Access Compliance Report

(Curb Ramps)

Intersection ID: 7966	Main Street: PAWTUCKETT_RD	Cross Street: SWIFT_ARROW_LN	Location:	N
ADA ID: 2ABA6C2BFCFB	Ramp Type: Perp	Initial Pass/Fail: Fail	Overall Compliance: No	Severity Score: 22.5
Codes/Mitigation Info/Possible Solution		Field Measurements/Component Compliance

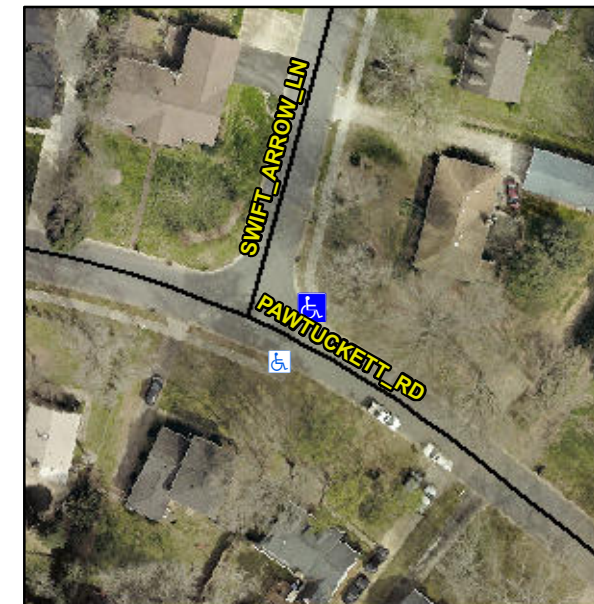
Not Found, R304.5.1, R304.2.2

Compliance	Description	Data	Compliance	Description	Data
N/A	Ramp Length (in)	46.0	No	Ramp Slope (%)	9.2
No	Ramp Width (in)	46.5	Yes	Ramp XSlope (%)	3.5
N/A	Flare Type LT	N/A	N/A	Flare Type RT	N/A
N/A	Flare Slope LT (%)	N/A	N/A	Flare Slope RT (%)	N/A
N/A	Flare Traversable LT?	N/A	N/A	Flare Traversable RT?	N/A
N/A	Landing Length (in)	N/A	N/A	DWS Provided?	N/A
N/A	Landing Width (in)	N/A	N/A	DWS Contrast?	N/A
N/A	Landing Slope (%)	N/A	N/A	DWS Length (in)	N/A
N/A	Landing X Slope (%)	N/A	N/A	DWS Full Width?	N/A
N/A	Landing Curb? (Y/N)	N/A	N/A	DWS Offset (in)	N/A
N/A	Shared Landing?	N/A			
N/A	Gutter Ponding?	N/A	N/A	Gutter Slope (%)	N/A
N/A	Gutter Lip Ht (in)	1.5	N/A	Gutter X Slope (%)	N/A
N/A	Painted X Walk1?	No	N/A	Painted X Walk2?	N/A
	X Walk 1 Direction	To SW		X Walk 2 Direction	N/A
N/A	X Walk 1 Width (in)	N/A	N/A	X Walk 2 Width (in)	N/A
	X Walk 1 Slope (%)	1.8		X Walk 2 Slope (%)	N/A
	X Walk 1 X Slope (%)	3.5		X Walk 2 X Slope (%)	N/A

Remove & Replace Entire Ramp.
